# Access Compliance Report

## Public Rights-of-Way

### (Island Curb Cuts)

| Intersection ID: 10036503               | Main Street: ROZZELLES_FERRY_RD | Cross Street: N/A                       | Location: N/A          |

| ADA ID: 7266BF4F5E2A                    | Curb Cut Type: MedianRefuge2    | Initial Pass/Fail: Fail                 | Overall Compliance: No |

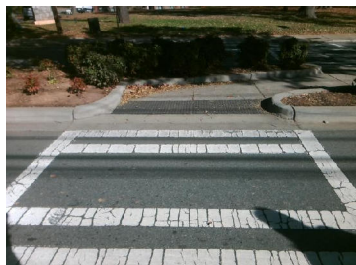
| Compliance | Description          | Data  | Compliance | Description                 | Data |
|------------|----------------------|-------|------------|-----------------------------|------|
| No         | Refuge 1 Width (In)  | 51.5  | N/A        | Gutter 1 Lip Ht (In)        | N/A  |
| No         | Refuge 2 Width (In)  | 51.5  | N/A        | Gutter 2 Lip Ht (In)        | N/A  |
| No         | Refuge 2 Slope (%)   | 5.1   | N/A        | Gutter 2 Slope (%)          | N/A  |

**Remove & Replace Entire Refuge.**
